TOWNSHIP OF FRANKLIN
Planning Board
Agenda
Wednesday, December 3, 2025

NPH REAL ESTATE, LLC / PLN-24-00005

Preliminary & Final Major Site Plan w/C Variances in which applicant seeks to construct a 24,670sqft shopping center at 390 Davidson Avenue, Somerset; Block 502.01 Lot 57.01 in zone B-I & RDO

Figure 8: Nearby Examples of Landscaped Frontage and Corner Treatment

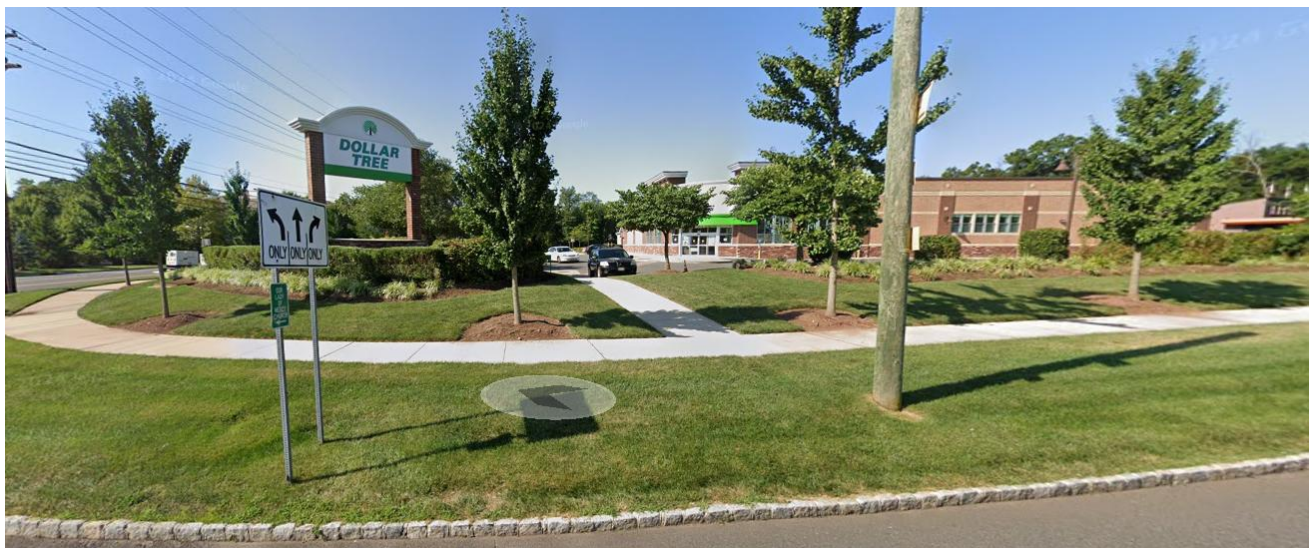
- §112-206.9.A.(3)(c) encourages special landscape design that incorporate “corner features” at street intersections. Figure 9 provides a nearby example of how this was addressed per this standard
- §112-206.9.A.(3) encourages “entryway landscaping announces and highlights entries into the development for the visiting public”
- Figure 8 shows examples of two nearby developments at the intersection of Elizabeth Avenue/ Schoolhouse Road which each incorporate design features consistent with §112-206.9.A.(3)(c) – special design treatment near the intersection.
